**IMPORTANT SAFETY RECALL
NATIONAL HIGHWAY TRAFFIC SAFETY ADMINISTRATION
NHTSA RECALL NO: 24E026**

Freedman Seating Company (FSC) has decided that a defect which relates to motor vehicle safety exists in certain GO-ES Spacesaver Foldaway Seats manufactured between December 11, 2023 and January 31, 2024. The seat back cushion may become disengaged from the dump mechanism when there is a high load applied to the shoulder portion of the seat belt.

GO-ES SpaceSaver Foldaway Service Instructions

Inspection Step 2

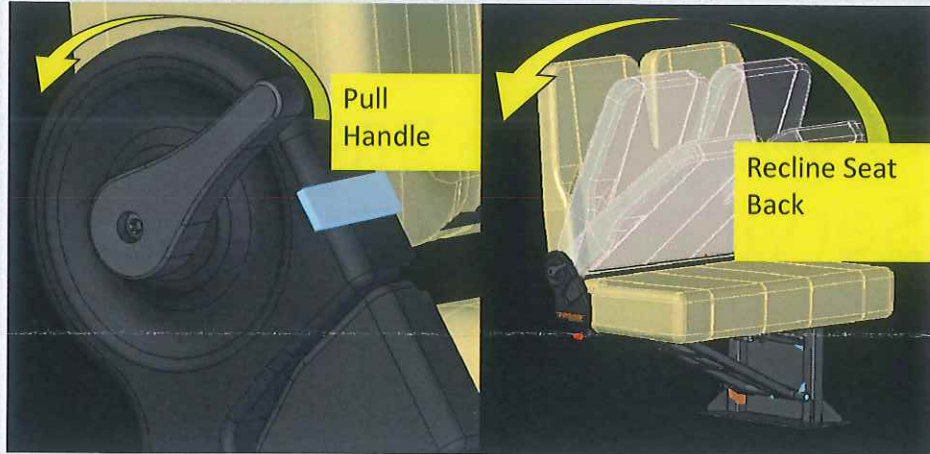
Pull the handle to release the seat back and actuate the back into the most reclined position

Inspection Step 3

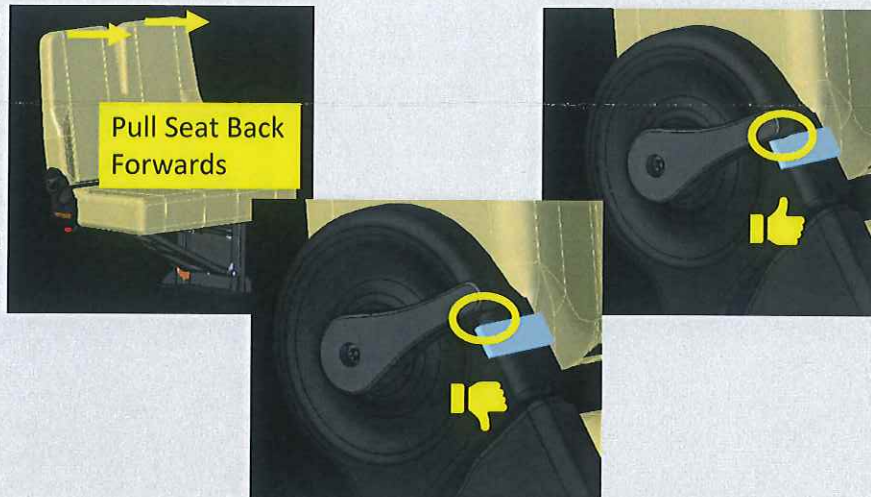
Release handle and pull seat back forward

If handle returns back to original position, no additional work needed

If handle does not return back to the original position then seat will need to be reworked
